**VALUE ENGINEERING STUDY
OF
*FALL LINE FREEWAY***

**Atlanta, Georgia
January 24-26, 2006**

**Prepared by:
*VE GROUP, L.L.C.***

**In Association With:
GEORGIA DEPARTMENT OF TRANSPORTATION**

AS PROPOSED

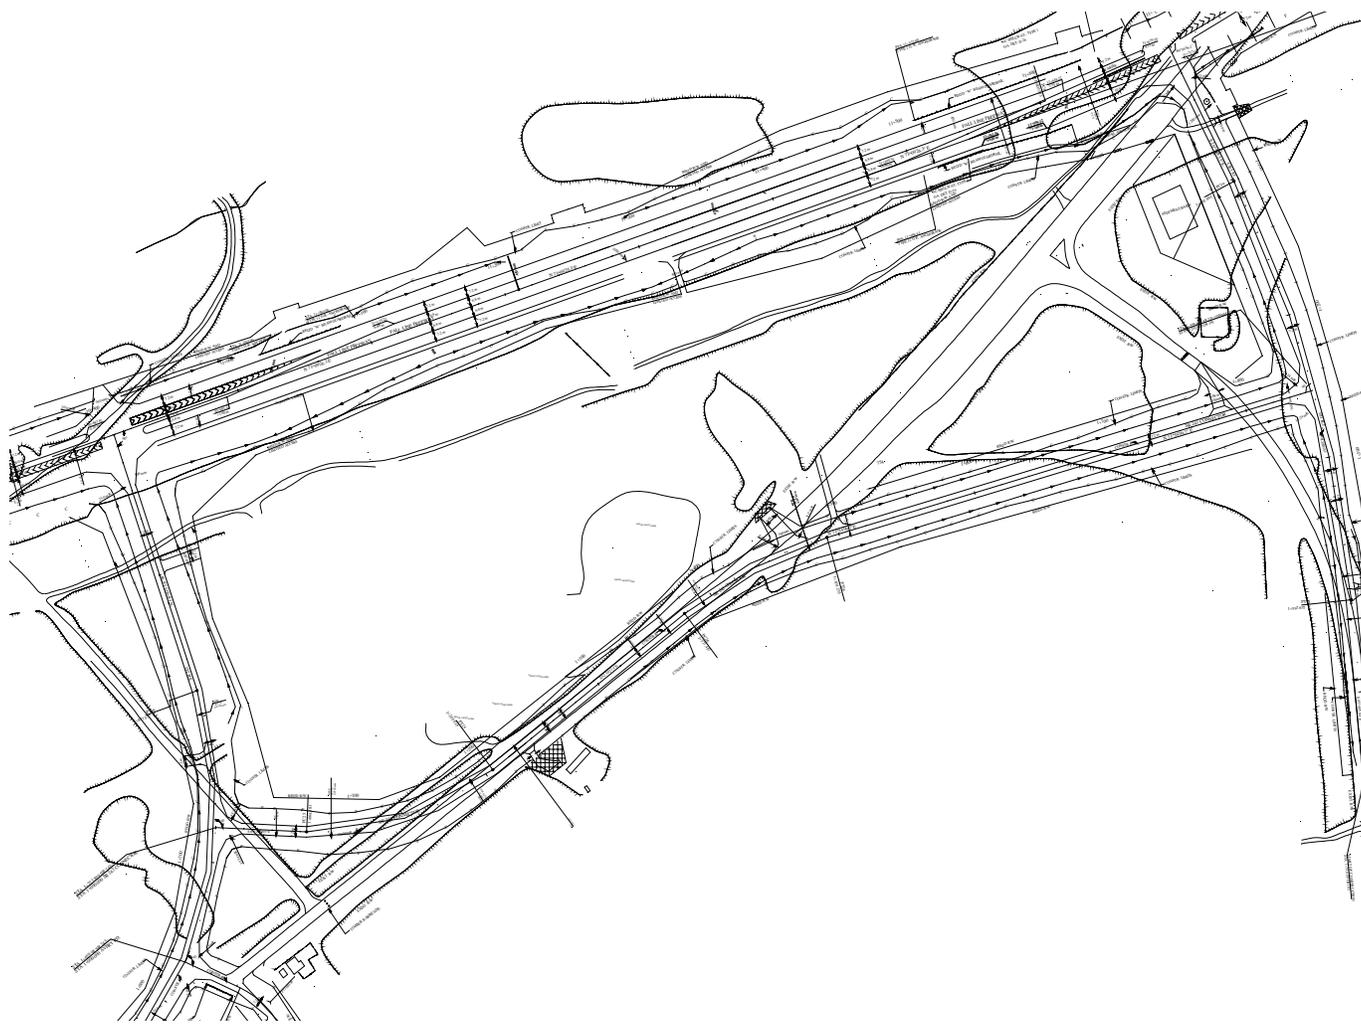
Existing SR 243 intersects SR 24 with a large skew and CR 183 “T’s” into SR 243 before it intersects with SR 24. The “As Proposed” design removes the large skew intersection with SR 24 by constructing 2 “T” intersections on SR 24, to 1 for SR 243 and 1 for CR183. These 2 intersections are 793 meters (2600 feet) apart. The As Proposed design requires the demolition of:

- 370 meters of CR 183
- 710 meters of SR 243

The Value Engineering Team recommends replacing the 2 “T” intersections with a single “T” intersection about halfway between the 2 proposed intersections. The plan below shows a Modern Day Round About as an intersection between SR 243 and CR 183; a “T” intersection could easily replace the Round About if the Department wishes.

AS PROPOSED

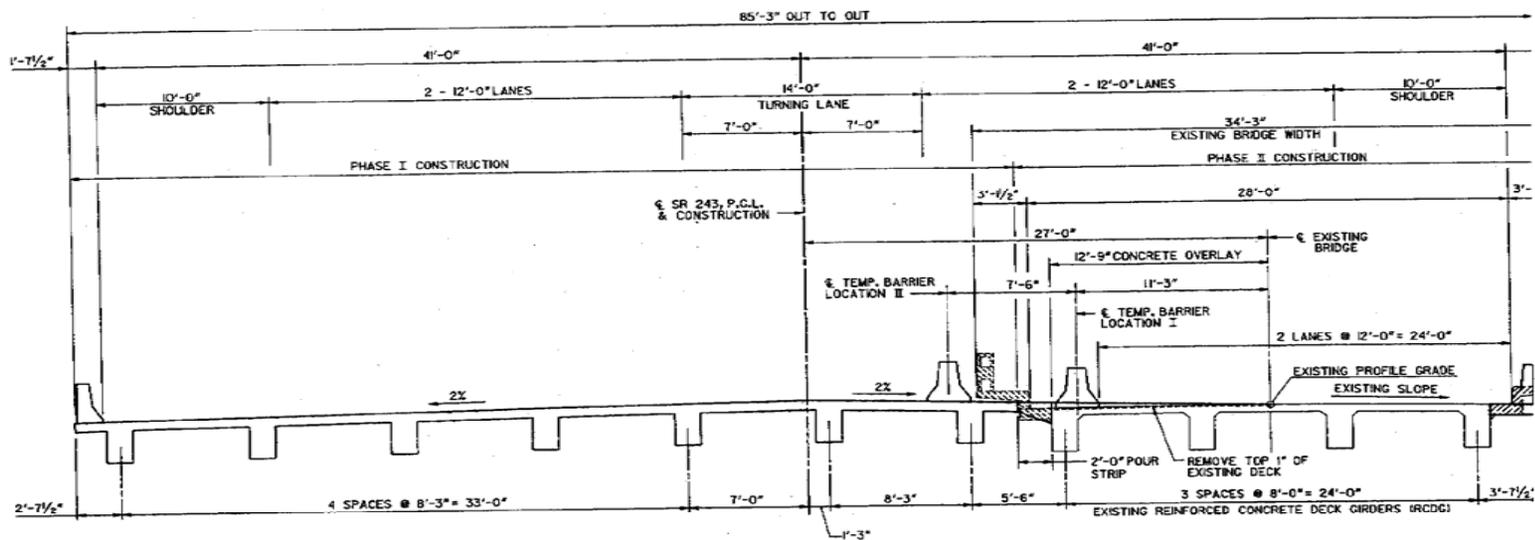
Approximately 500 feet from the beginning of the project is an existing bridge over Little Commissioner Creek and Lake Tchukolako. The project plan proposes to widen this bridge to the left in two phases. The first phase will remove the existing handrail and curb, place a temporary barrier on the existing bridge, and construct some 55 feet of new bridge. Traffic will then be shifted to the new bridge. The handrail and curb will be removed from the existing bridge, a new barrier constructed on the right side, a two-foot tie strip will be poured between the 2 structures, and a concrete overlay, will be placed on the original westbound lane to correct the cross slope. The resultant structure will have 2 12-foot lanes in each direction, a 14-foot center turning lane, and 10-foot shoulders on each side.

AS PROPOSED DIAMOND INTERCHANGE

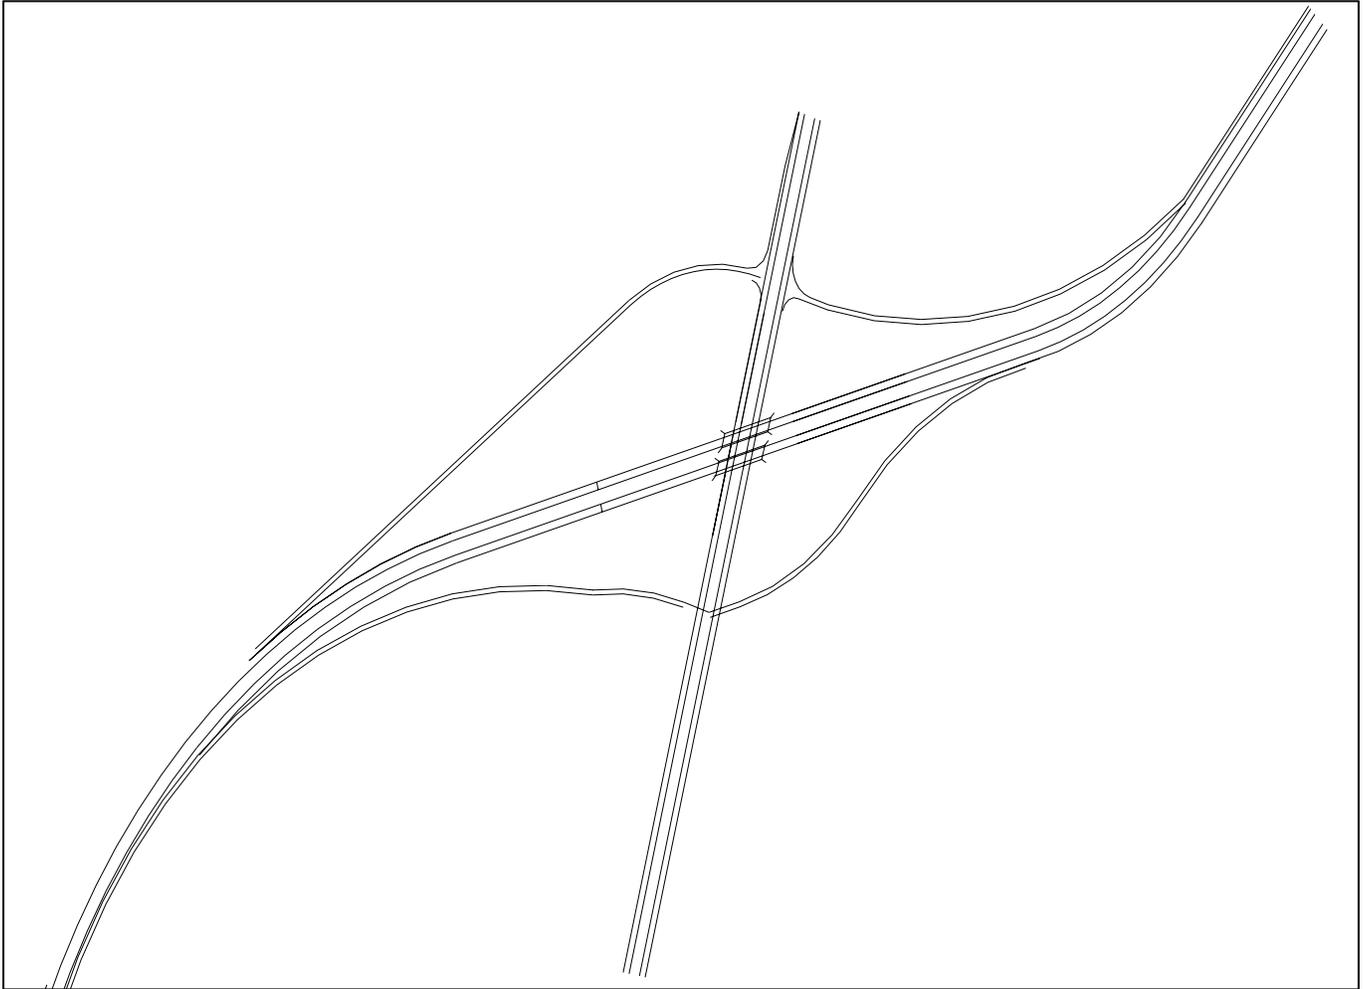
The Value Engineering Team was informed at the briefing that the projected traffic for this project would not warrant an interchange. An interchange was included only to avoid conflicts between the 2 intersecting roadways. It is the belief that a properly designed and constructed at-grade intersection will also provide the function of avoiding conflict between the 2 roadways, therefore the Value Engineering Team recommends constructing a signalized at-grade intersection as shown below. The intersections will include:

PLAN AND ELEVATION
 SR 1085 FALL LINE FREEWAY OVER REEDY CREEK
 BALDWIN COUNTY EDS-0000-00(346)

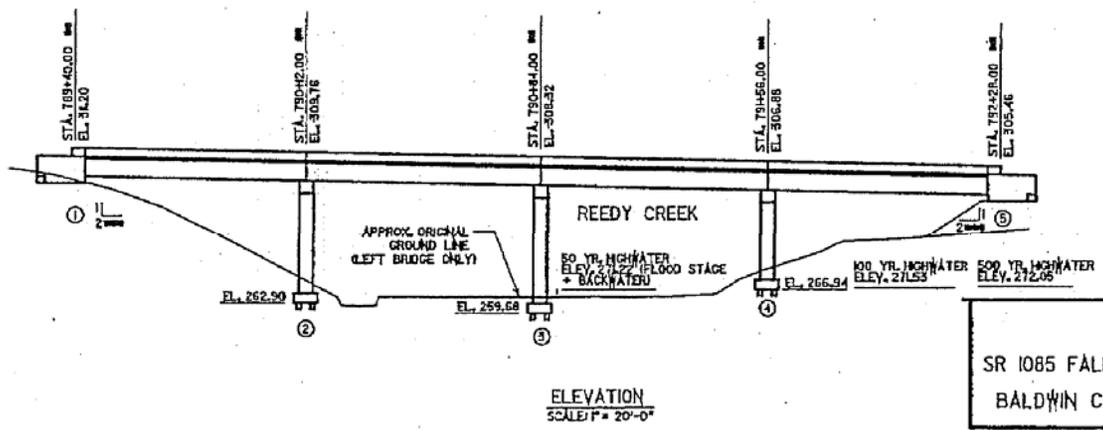
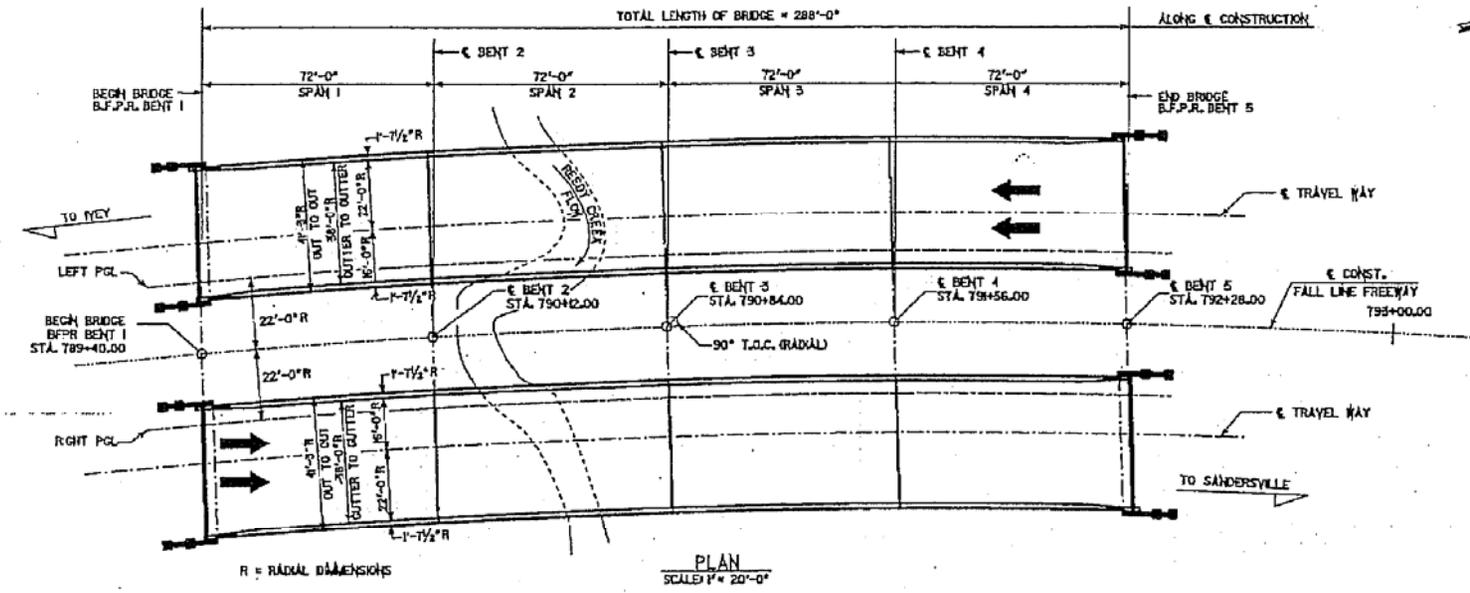
- More bridge than hydraulically required.
- Hydraulic flows are restricted by double box culvert in close proximity upstream.
- High construction cost.
- High future bridge maintenance.
- Longer construction time.

It is therefore the recommendation of the Value Engineering Team that the double bridges proposed for this project be replaced by the use of a bottomless 18-foot x 8-foot culvert. This culvert would be approximately 240 feet in length and would cost an estimated \$1,000 per linear foot. A cross-sectional and a three-dimensional view are attached as the value engineering alternative. By using this application, there could be an estimated savings of more than \$1.9 million.

FLF 540 (346)
BUCK CREEK

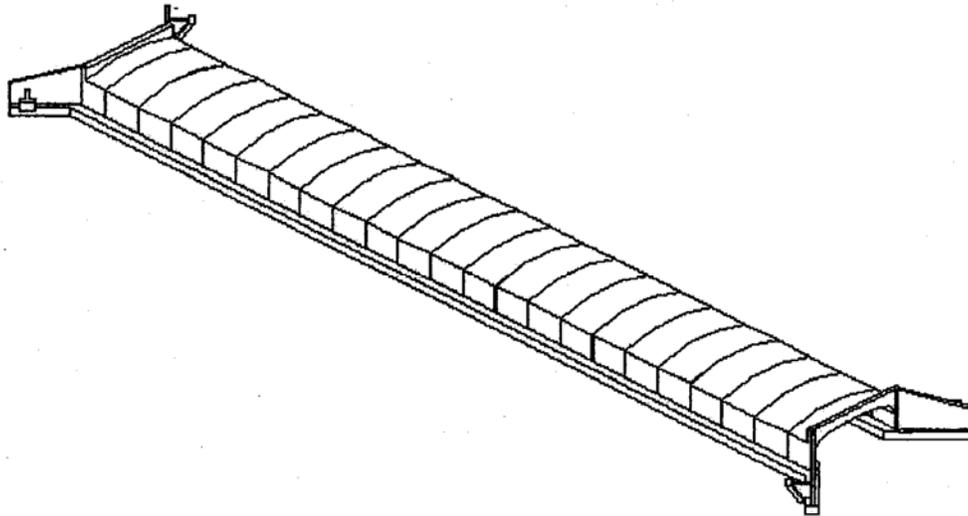
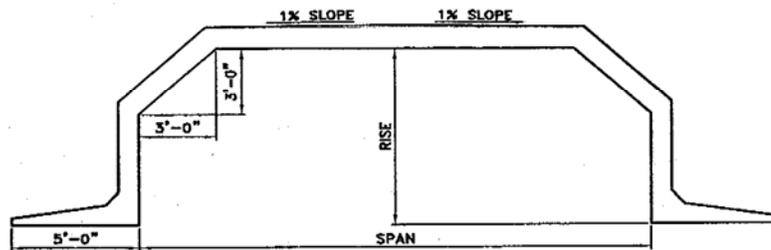
The recommendation of the value engineering study is to replace the proposed quadruple 10-foot x 10-foot concrete box culvert with a bottomless 40-foot x 10-foot culvert. This culvert would be the same 260 feet in length and would cost an estimated \$1,400 per linear foot. This compares with an estimated cost of \$3,650 per linear foot to construct a conventional quadruple concrete box culvert. A cross-sectional and a three-dimensional view are attached as the value engineering alternative. By using this application, there could be an estimated savings of more than \$702,000.

SR 24 OVER BLUFF CREEK
 BALDWIN/WASHINGTON CO., GA FLF-540(26)

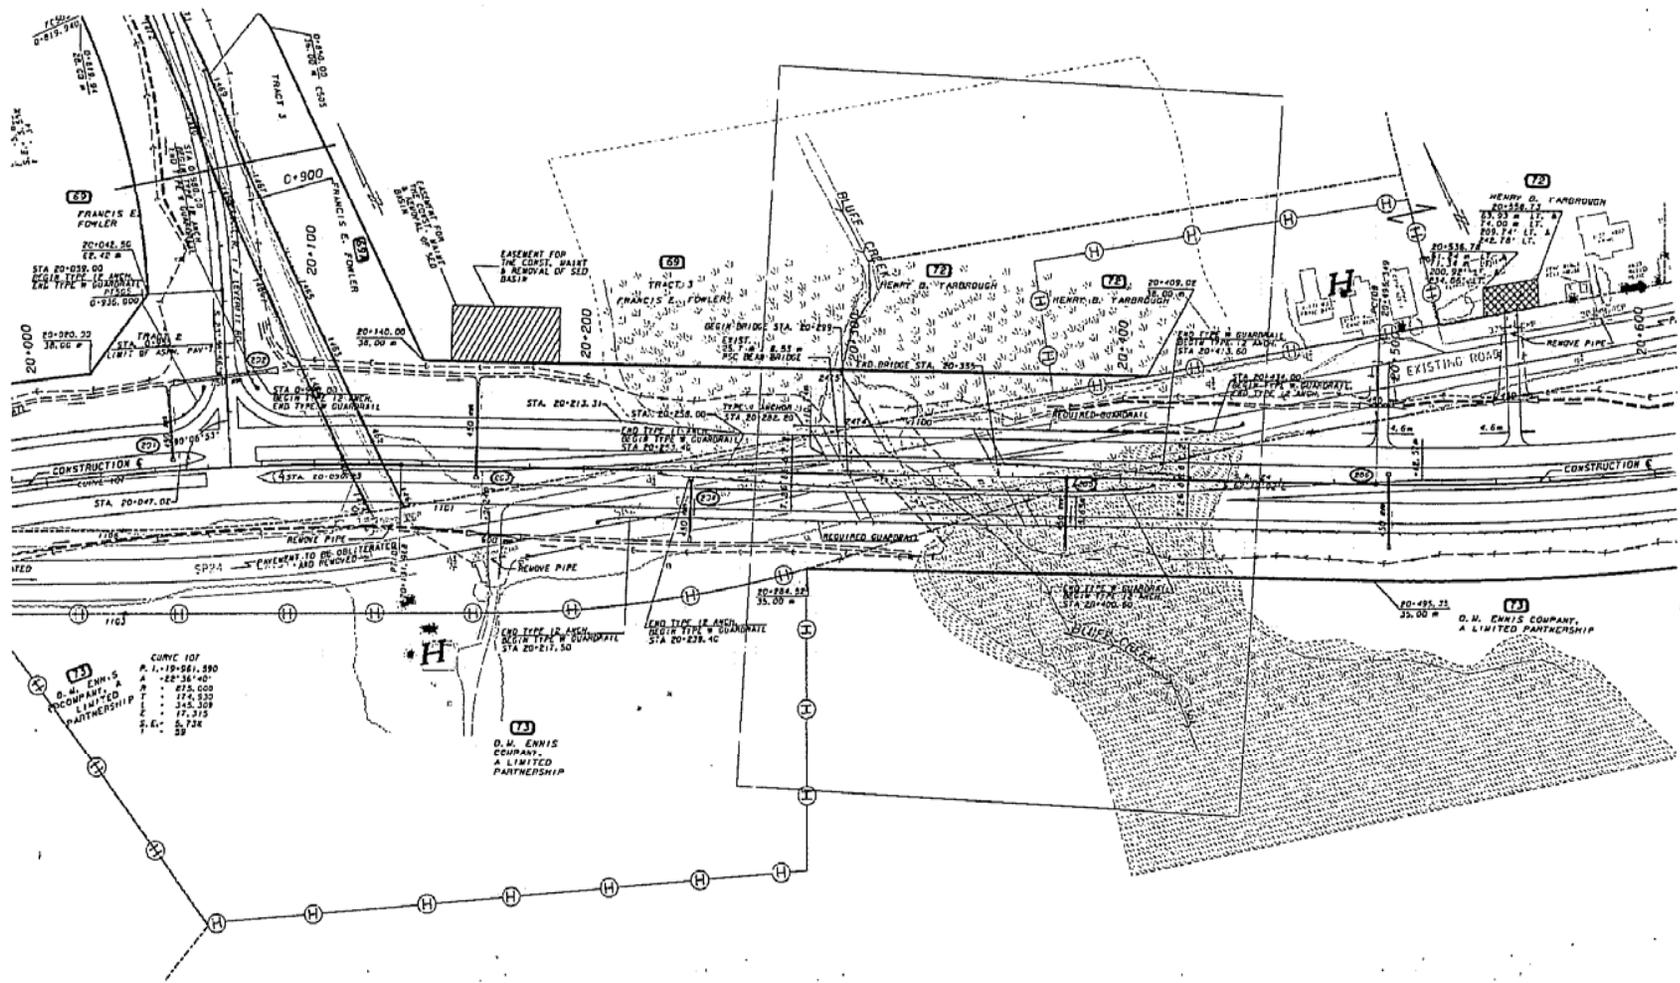
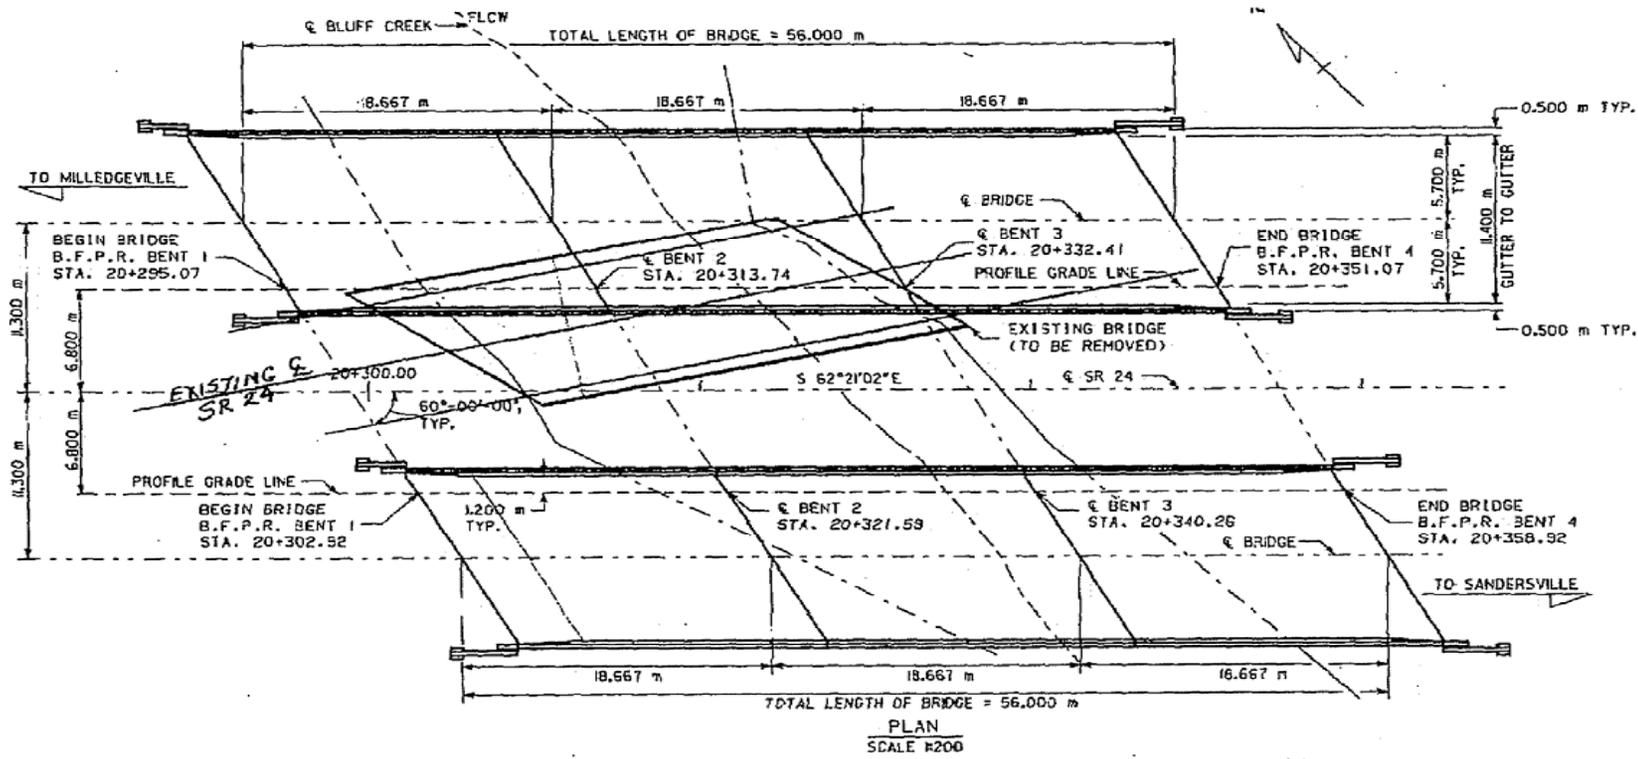
The proposed alignment is on a skew with the existing bridge, and proposes to construct 2 new parallel bridges over Bluff Creek. These bridges are each 56 meters long and 11.4 meters wide. The bridges are 3-span with the span length of each being 18.667 meters. The estimated cost of these new structures is almost \$1,170,000. The proposed staging for the project is to construct the right bridge first, shift traffic to the new bridge, remove the existing bridge and then construct the left bridge.

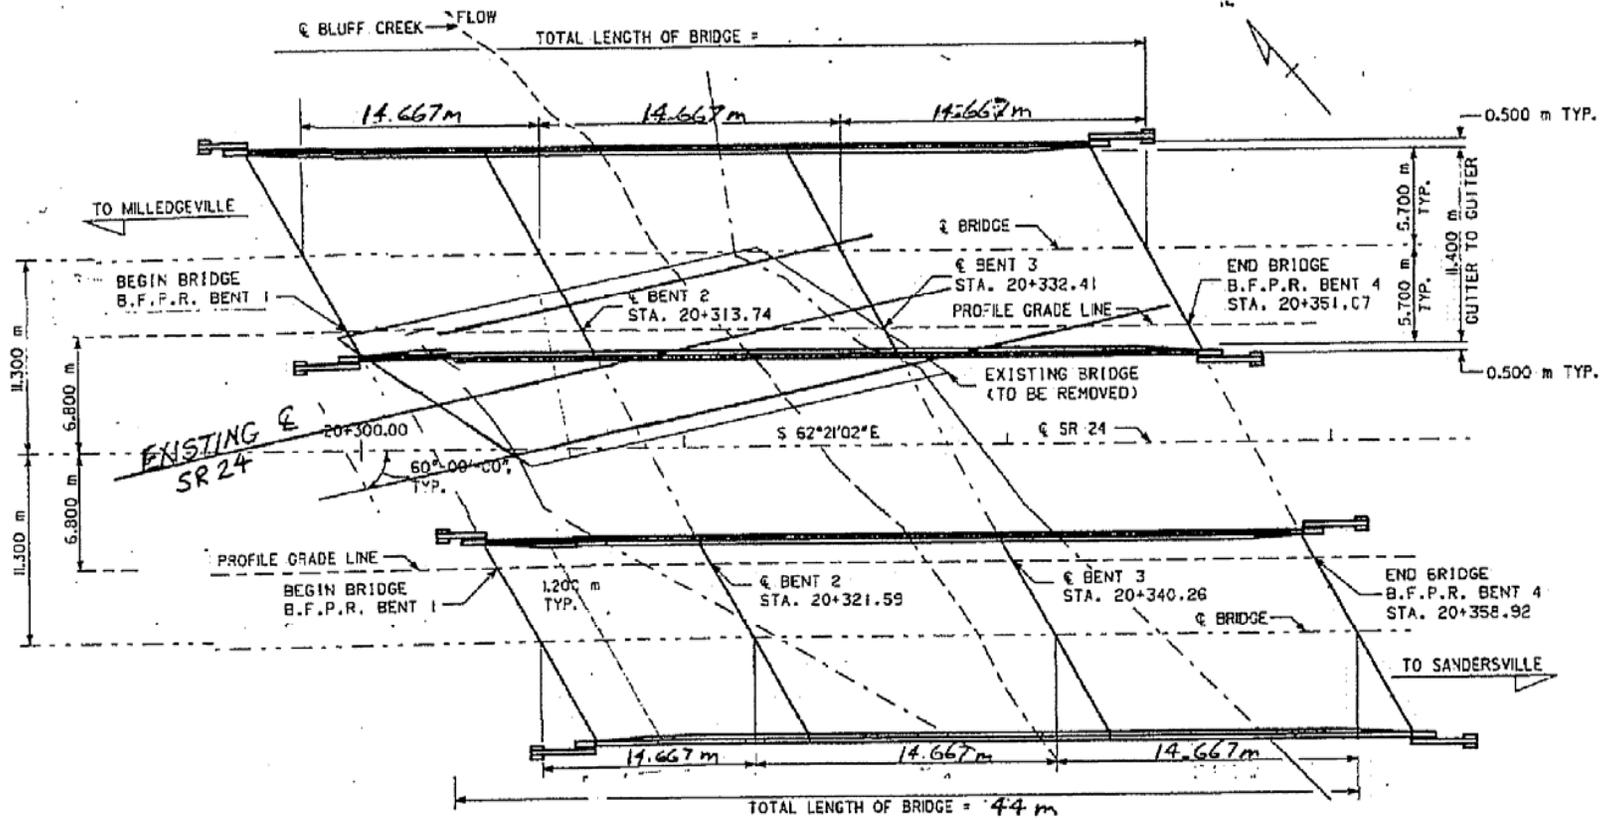
As can be seen from the plan view of the “as proposed” plans, the existing bridge is partially contained within the median of the proposed roadway. In fact, the end of the proposed right bridge is less than 10 feet from the existing edge of pavement. It is the conclusion of the study team that the “as proposed” cannot be constructed due to this extremely close proximity between the new and the old bridge.

There are several ways to amend this situation. The proposed alignment crosses the existing bridge on a skew. The alignment could be changed to parallel the existing alignment. However, there is historical property to either side of Bluff Creek. Changing the alignment would impact these properties.
